MITSUBISHI MOTORS

SERVICE BULLETIN

PURPOSE : CORRECTION	ISSUE NO. : MSB-11E42-501	DATE : 2011-06-20
SUBJECT : DOOR-SIDE DOOR HINGE MOUNTING BOLTS TIGHTENING TORQUES		<MODEL> (EUR) i-MiEV (HA3W) <M/Y> 11–12
GROUP : BODY

Tightening torques for the door-side door hinge mounting bolts have been incompletely specified in the applicable Workshop Manuals. This Service Bulletin contains the corrected descriptions.

DOOR ADJUSTMENT

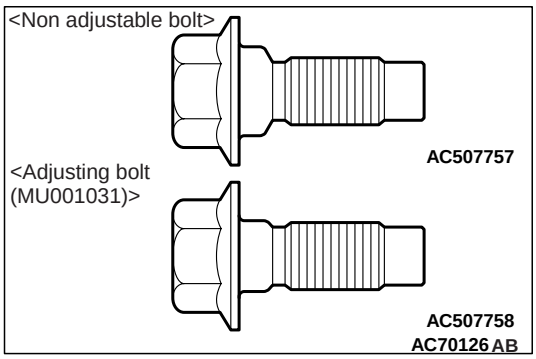
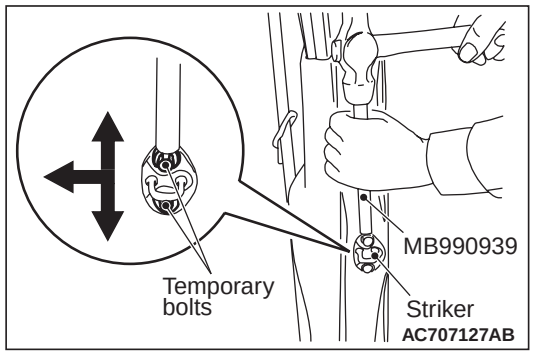
<Deleted>

~~**Tightening torque <excluding two-tone paint>: 25±7 N·m**~~

~~**Tightening torque <excluding two-tone paint>: 35±5 N·m**~~

<Added>

Bolt	Paint	Torque
Non adjustable bolt 	With	25 ± 7 N•m
	Without	35 ± 5 N•m
Adjusting bolt (MU001031) 	Without	35 ± 5 N•m
